**CITY OF WEST DES MOINES
STAFF REPORT COMMUNICATION**

ITEM: 485 S. 19th Street – Approve Site Plan to allow construction of a two-story duplex building – Silo 9 Plat 1, LLC – SP-005409-2021

Resolution: Approval of Site Plan

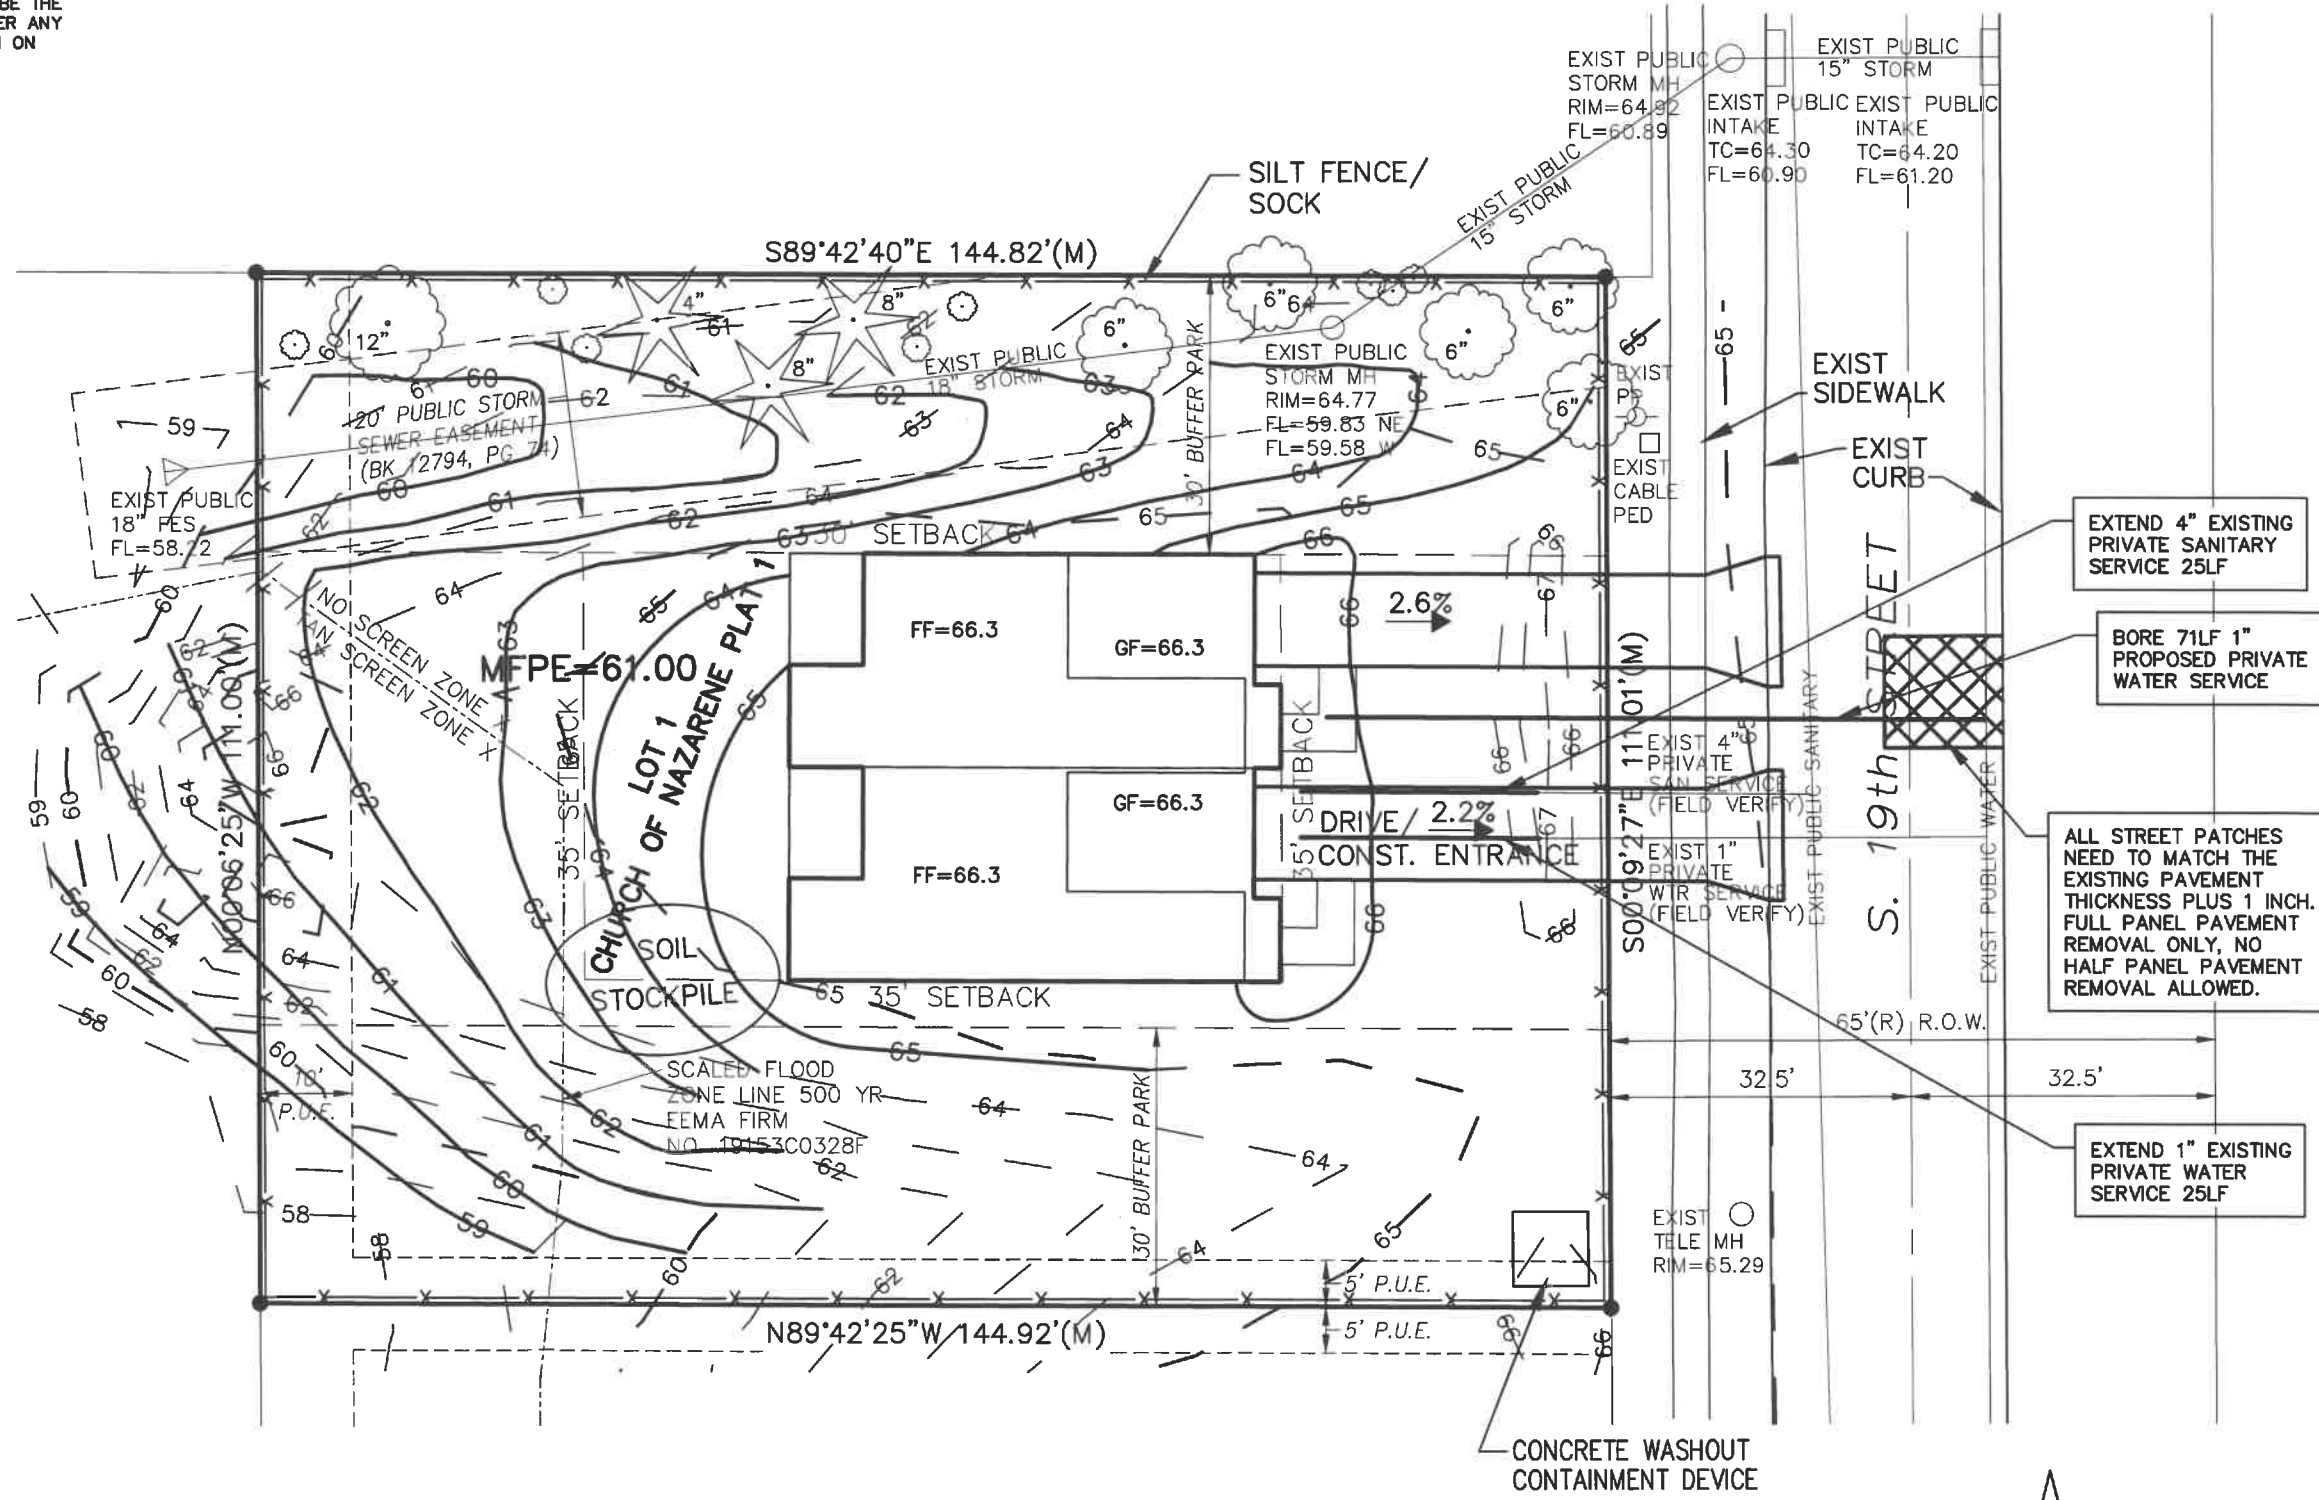
- **Grading:** The site plan indicates grading across the property line of the lots which can be allowed with the permission of the adjoining property owner and execution of a temporary grading easement. Since the developer has not obtained an easement, it has been indicated that the drawings will be revised to remove any grading on the adjoining property. Staff recommends a condition requiring the submittal of revised drawings or provision of an executed grading easement prior to issuance of a building permit for the duplex.

1. The applicant executing a 30' Buffer Park Easement prior to issuance of a building permit.
2. The applicant submitting revised drawings that reflect no grading across property lines or obtaining the proper grading easement from the adjoining owner prior to City Council consideration of the site plan.
3. The applicant providing illustrations and manufacture details on building colors and materials to be implemented which are acceptable to the city prior to City Council consideration of the site plan.

485 S. 19TH STREET - LANDSCAPE PLAN

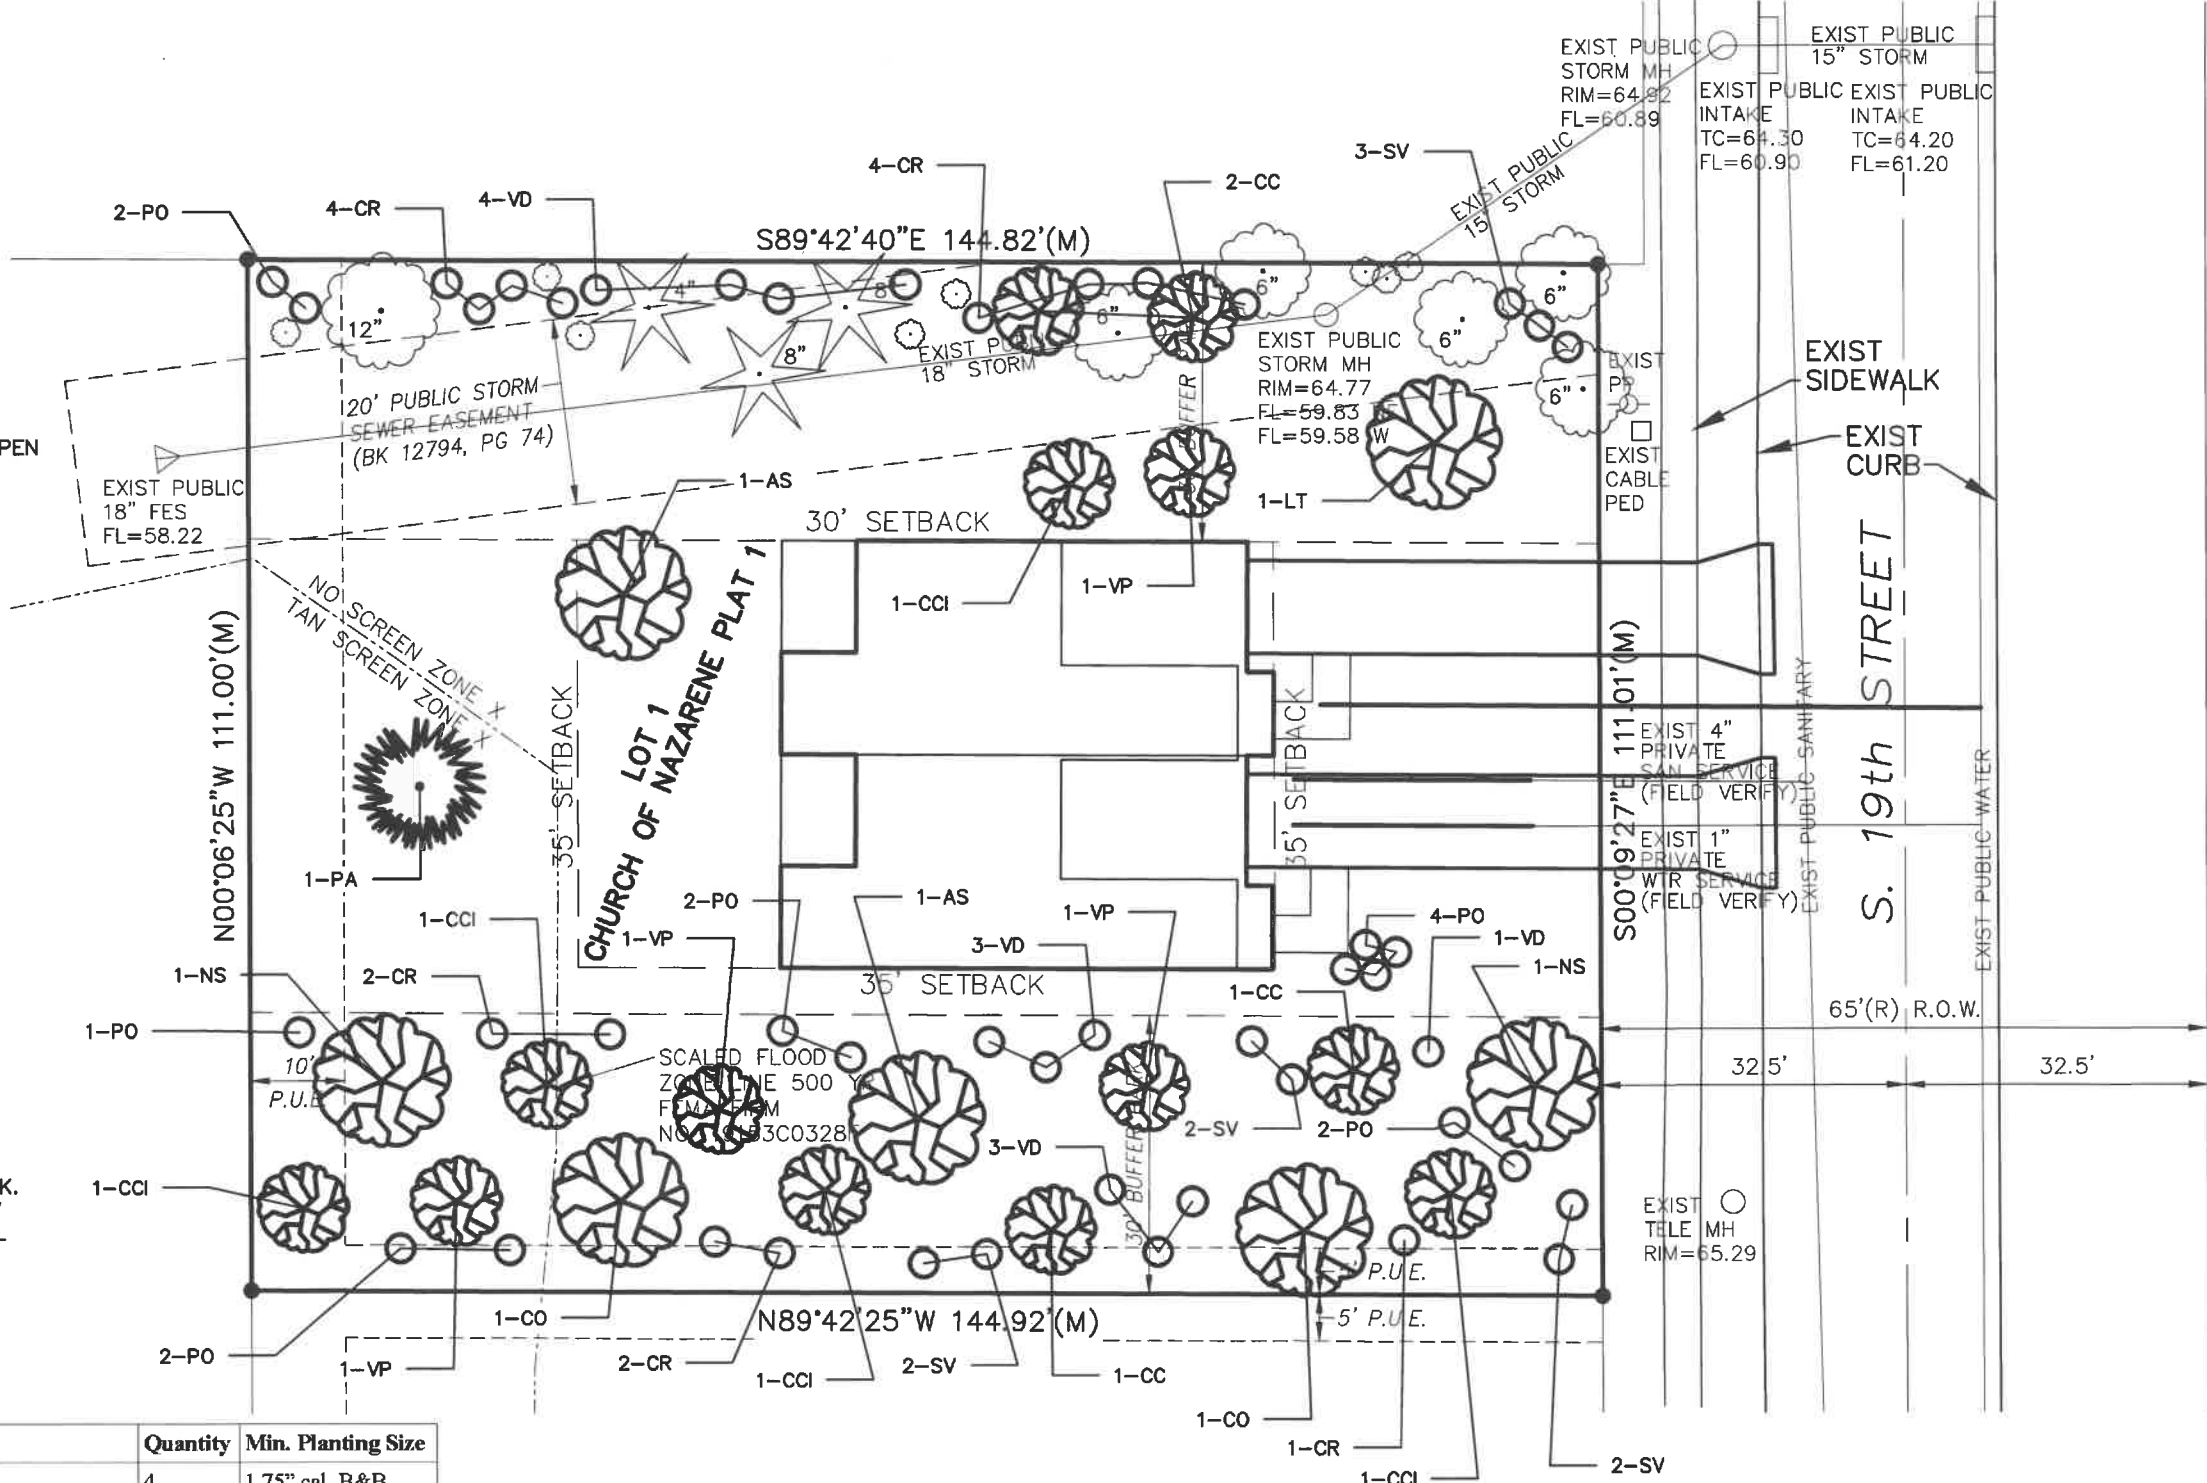
- **Buffer Parks:** Due to the subject property being of a higher intense use than the existing single-family home to the south, a 30' buffer is required along the south lot line. A 30' buffer along the north lot line was established in conjunction with the final plat that created the subject parcel (FP-2008-002). It appears that the buffer was indicated on the drawing, but no easement document was executed, therefore, Staff recommends a condition requiring the execution of the Buffer Easement document(s) prior to issuance of a building permit. The buffer easement will apply to both the north and south buffers. The project has been designed in compliance with the city's buffer requirements in terms of number of plantings and trees that will be implemented.

Elevations

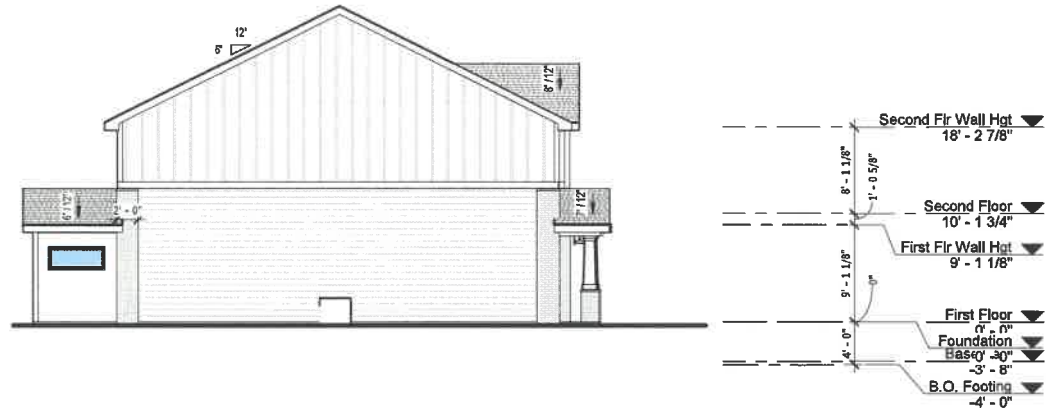
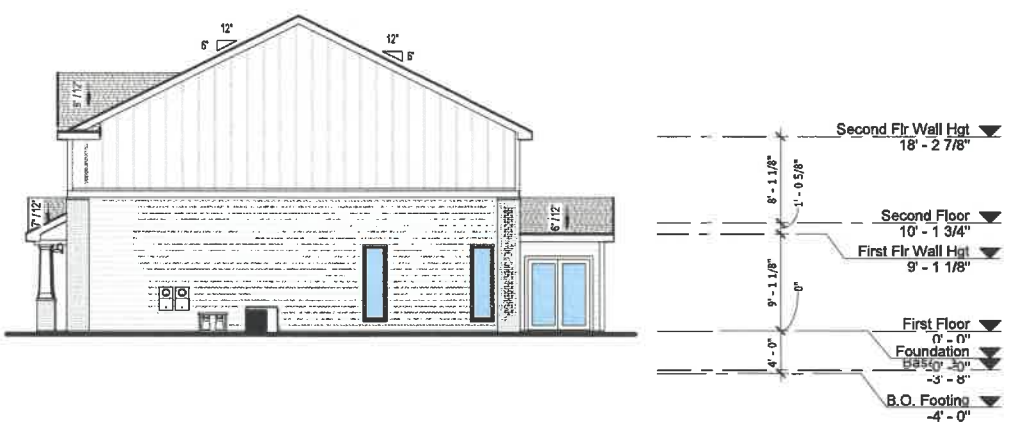
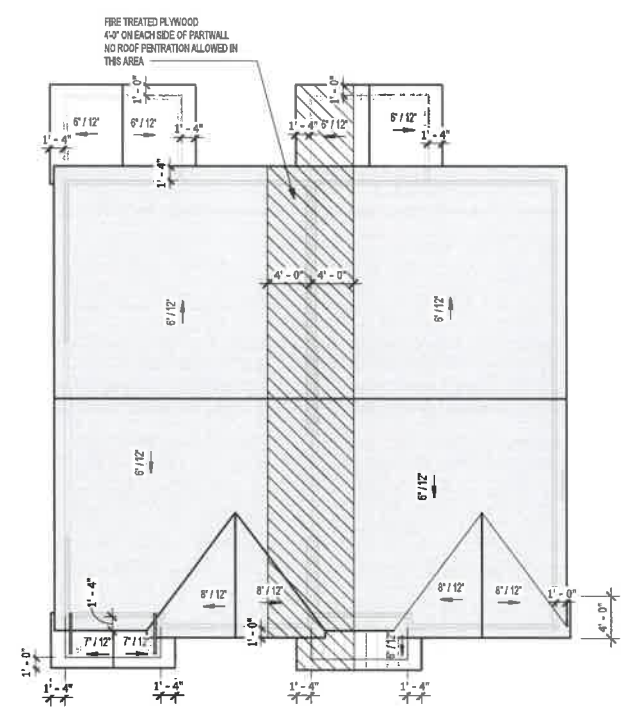
- **Architecture:** The developer and staff are still working through the architectural drawings but are down to just needing an illustration that identifies the materials and colors to be implemented. Staff recommends a condition of approval requiring the submittal of the illustration with material and color details prior to issuance of the building permit for the duplex.
